Southwest WWTP Notice of Requirement – Designate 372 Glenbrook Beach Road, Glenbrook - Section 92 Response

Appendix 1: Section 92 request for further information response

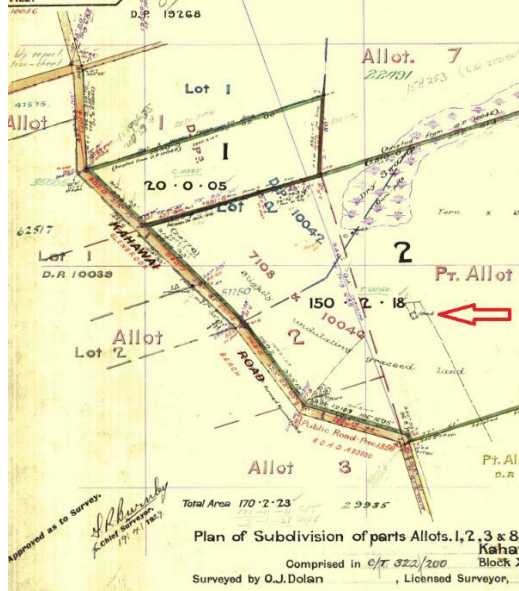
4	Planning – mana whenua engagement	Please confirm if mana whenua have provided any recommendations relating to the matters (as summarised in the AEE) raised following consultation?	Consultation with mana whenua has been covered in the AEE and appendix D. The key matters of concern to mana whenua have been summarised. It is unclear however if mana whenua have made any recommendations or have expressed any expectations (i.e. around native plantings) for this stage of the development process.	<p>During the Options Assessment phase, Mana Whenua raised the following matters:</p> <ul style="list-style-type: none"> • Sufficient setback is required from sensitive coastal headlands; • Avoid draining the wetlands on site; • Archaeologist to carry out on site assessment; and • Plant native trees. <p>As shown in the Indicative Design and Operational Report these matters are able to be incorporated in the design as all structures will be set back from the coastal</p>

#	Category of information	Specific request	Reason for request	Watercare Response
				<p>boundary and the wetlands to ensure sufficient separation is maintained. The Project Archaeologist completed a site walkover with Mana Whenua and there are no archaeological sites recorded at this site. As noted in the Landscaping Plan prepared by Boffa Miskell, native planting is proposed around the site.</p>
5	Landscape and visual amenity	<p>Has or can Watercare and / or its consultants considered architectural treatment (as mitigation) for the plant that would reduce its industrial profile and character, and lend it a more 'rural' appearance?</p>	<p>The Pukekohe plant on Parker Lane has a profile and visual signature that is markedly utilitarian and industrial in appearance – as shown in the photo below. However, it is located in a quite remote, visually recessive, location. By contrast, the proposed WWTP would be much more prominent near Glenbrook Beach Road, with vehicle movements to and from the settlements of Glenbrook Beach and Kahawai Point passing the proposed plant on a regular basis, while local residents living on 4-6 nearby properties would be more directly exposed to the plant. In order to ameliorate and mitigate the effects associated with such exposure, it would appear appropriate to employ measures designed to integrate the WWTP into its landscape setting, including the use of architectural forms, detailing and colouring that is sympathetic to its rural location. These concerns form the basis for this request.</p> 	<p>As Boffa Miskell has discussed in the assessment provided with the NoR, the views from Glenbrook Beach Road will not be an issue in the medium to long term due to the site being screened from view road users by the karo hedge proposed along the western site boundary. Visual impacts on the closest 4-6 residential properties have been taken into account in the AEE (see Appendix 9 - Landscape, Visual and Natural Character Effects Assessment). See in particular the Mitigation Planting Strategy within Appendix 5 of that report, as well as section 8 of the report which discusses how planting proposed under the Mitigation Planting Strategy will break up the scale and bulk of the structures, and where possible screen the project from adjacent properties.</p> <p>The articulation suggested of the proposed structures and buildings to integrate the WWTP into its landscape setting is unlikely to be possible. However, the use of more recessive colours and finishes within the Watercare colour palette and beyond if necessary will be explored. The intention will be to give buildings and structures a similar appearance to other large rural buildings in the wider landscape (see agricultural buildings at 91 Brookside Road below).</p>
